Product Change Notice

Smart Display PCB Solder Mask Change for Leopard, Cheetah and Saxon 4D 0.15

Below is the appearance comparison of HCMS-290x for reference:

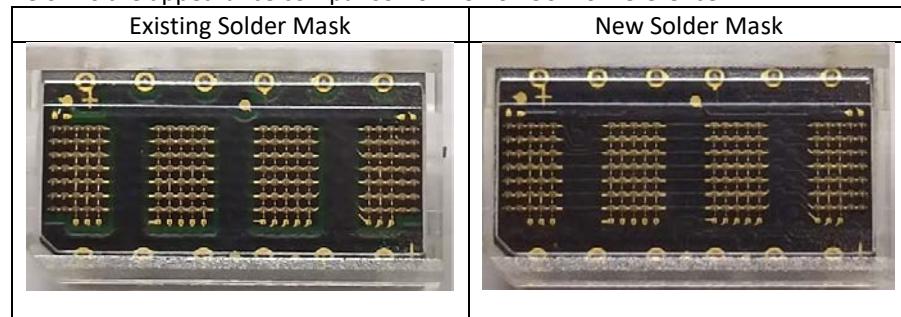
Solder mask optimization and material change. The new solder mask fully covers the PCB, providing a better cosmetic appearance.
